Longfellow Analysis

Reservoir Engineering Analysis

Spur Rebuttal Exhibit 2
Case No. 21733
June 17, 2021

Longfellow Completions Comparison

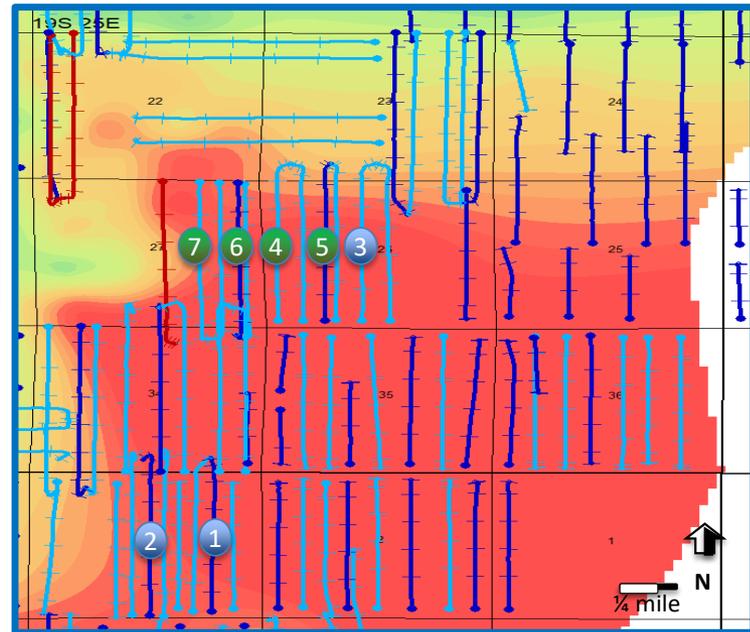
- * Longfellow chose wells ~25 miles away from Aid North / Hendrix ABX and in ~2.5x better rock quality to create type curves and attempt to justify their completion.

- * Spur does not believe Longfellow claim that their completion yields a 26% increase in EUR; Longfellow's analysis is inherently flawed.
- * Upper Paddock wells used are irrelevant to planned Aid North / Hendrix HSU developments.
- * Well set should be expanded and focus on lower Paddock only.
- * While completion uplift is evident across the Yeso play, incremental recoveries cease at Spur's design.

Spur Completions Comparison

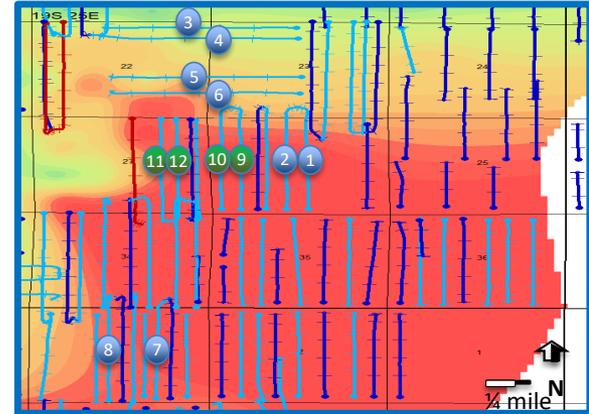
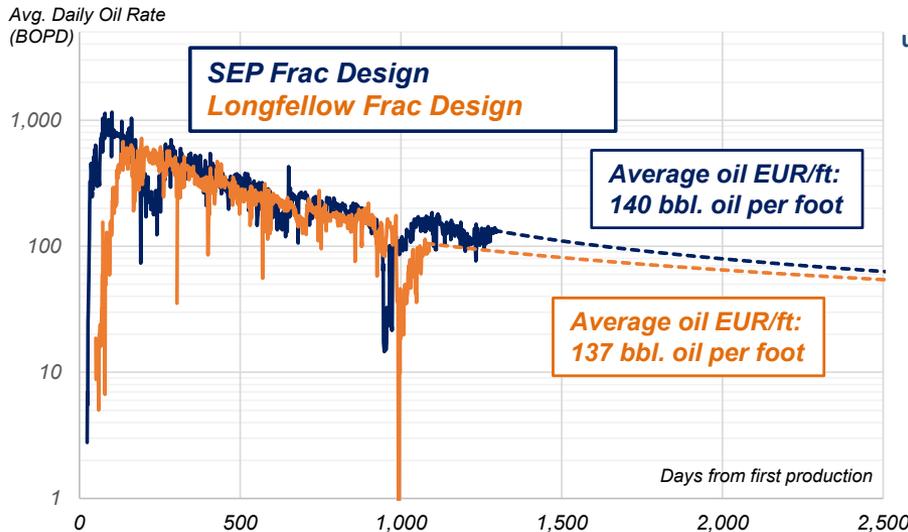
- * No appreciable difference in well EURs from Longfellow larger completion design
- * Longfellow frac design is copied from Percussion Petroleum's testing (Percussion acquired by Spur)
 - * Percussion ceased this design after simple cost – benefit analysis
 - * Spur is implementing superior and more capital efficient completion design
 - * Longfellow is implementing higher cost completion not supported in the empirical well results

Longfellow Development Plan

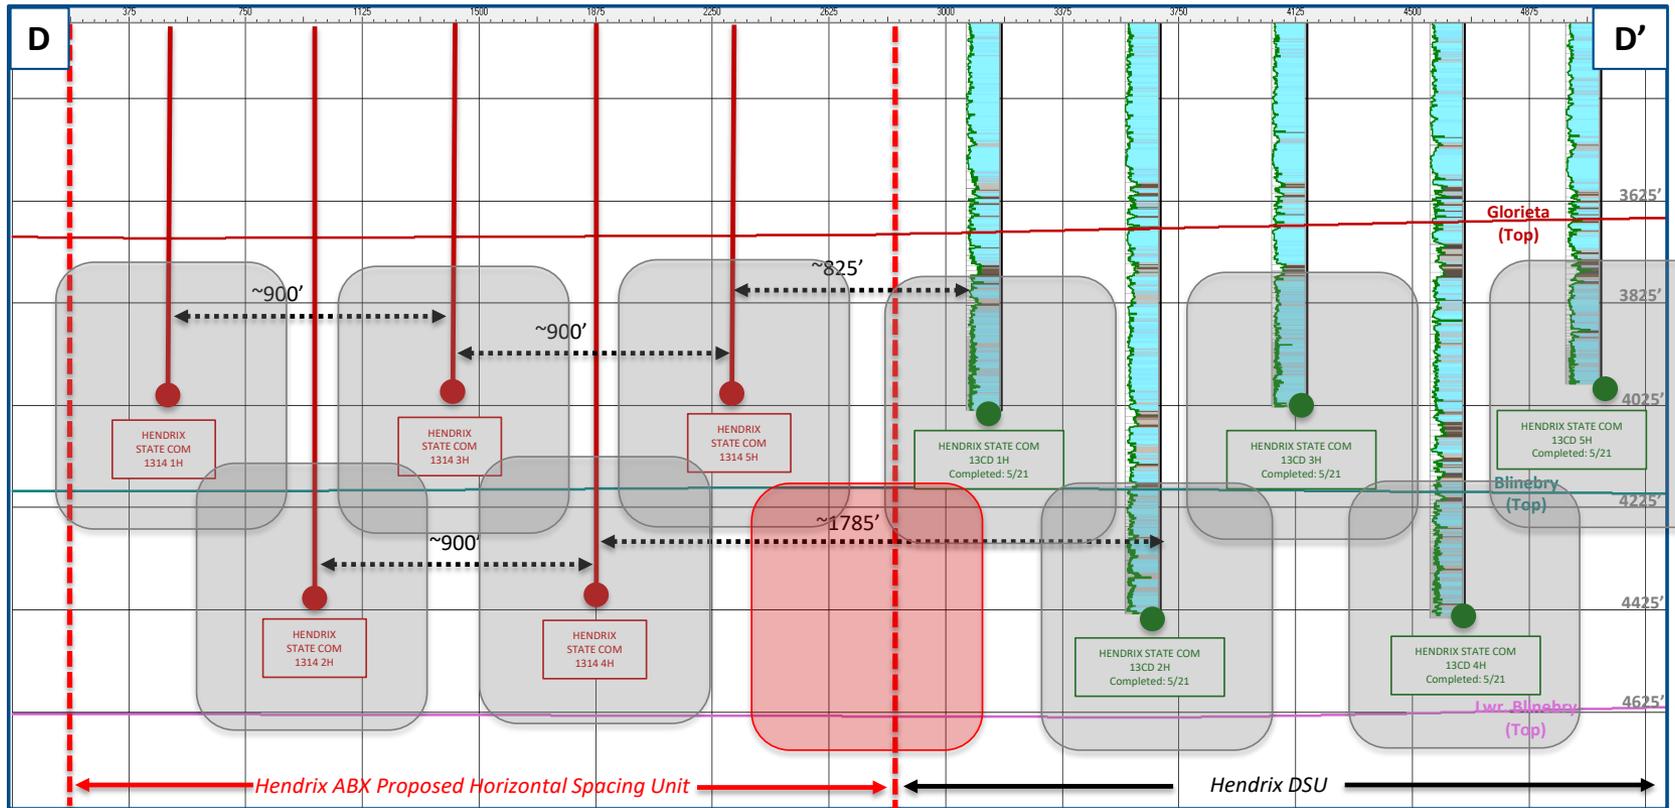
-  Drainage Area as defined in LFE Reservoir Engineering Analysis Exhibits
-  Stranded Blinebry in LFE development plan
